**Technical Service
BULLETIN**

FUEL INJECTOR "TICKING" NOISE

'01 – '05 Highlander (V6)

ENGINE
REVISÉD
EG013-05

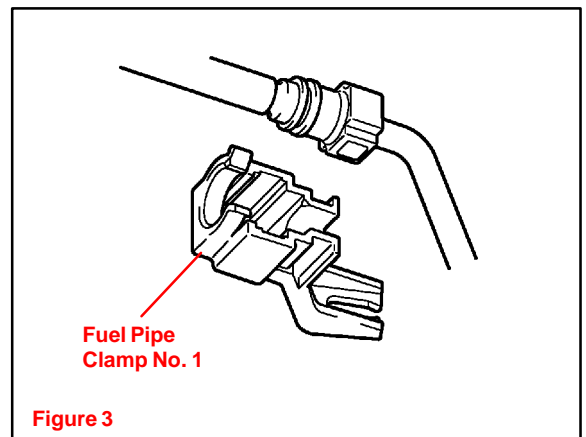
2. Disconnect Fuel Pipe Sub-assembly No. 1.

- Ensure that the removed bolt and washers are discarded.
- Refer to the "Component Identification" section on page 2 to ensure that the correct bolt and washers are removed and damper is installed.

- A. Disconnect the fuel pipe clamp No. 1 from the connector.
- B. Check if there is any dirt or mud on the pipe and around the connector before disconnecting the fuel line. Clean if necessary.

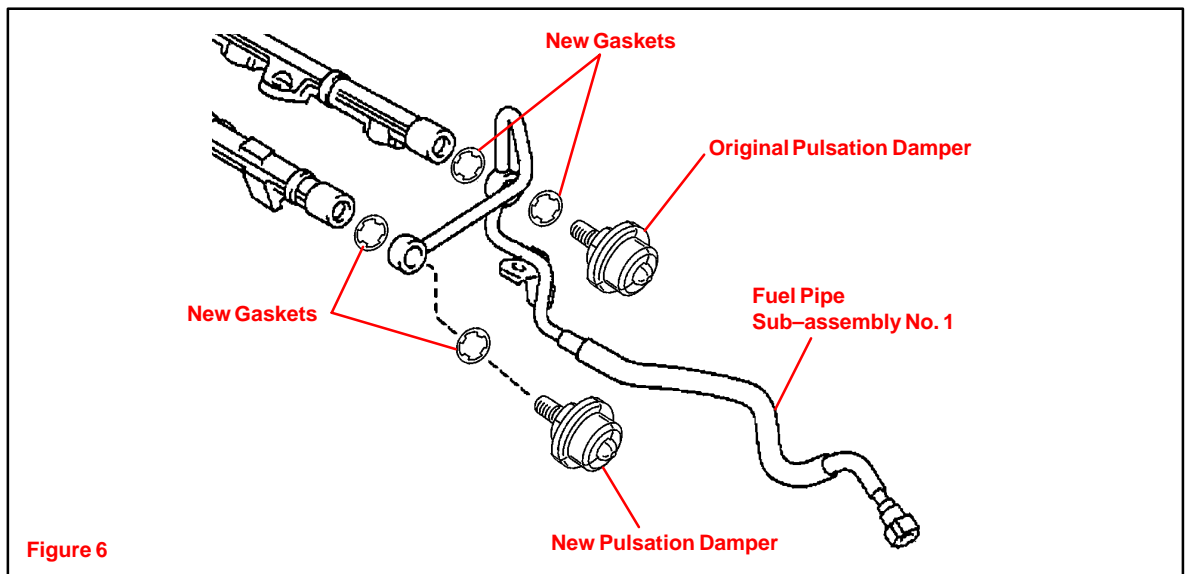
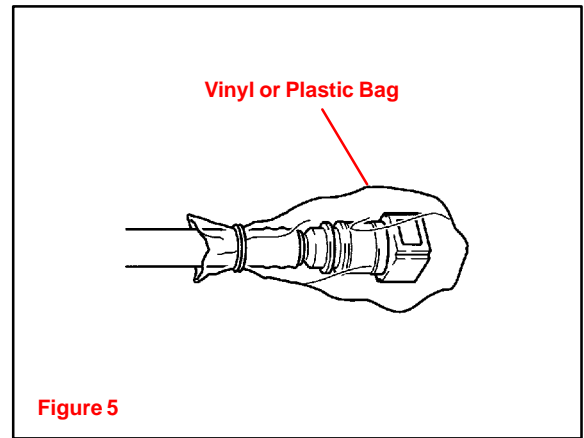
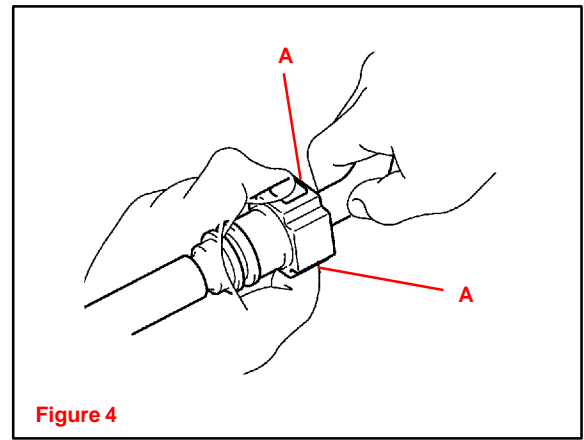
- C. Disconnect the connector from the hose while pinching portion "A" with your fingers as shown in the illustration.
- D. If the connector and pipe are stuck, pinch the fuel pipe, push and pull the connector by hand to disconnect them. Do not use any tools.
- E. Drain the fuel that remains inside Fuel Pipe Sub-assembly No. 1.
- F. Place a tray under the vehicle or point of disconnection, if needed, to catch any fuel that may spill.
- G. Protect the disconnected fuel lines from debris by covering with a vinyl or plastic bag.
- H. Remove the original pulsation damper from the rear fuel rail.
- I. Remove and discard the remaining bolt holding Fuel Pipe Sub-assembly No. 1 to the front fuel rail.

- 3. Install the new Fuel Pipe Sub-assembly No. 1 onto the vehicle.
- 4. Install both the original pulsation damper and the new (additional) damper with the new fuel pipe hose gaskets as shown, and torque to the following specifications.
Torque: 33 N•m (24 ft•lbf, 331 kgf•cm)
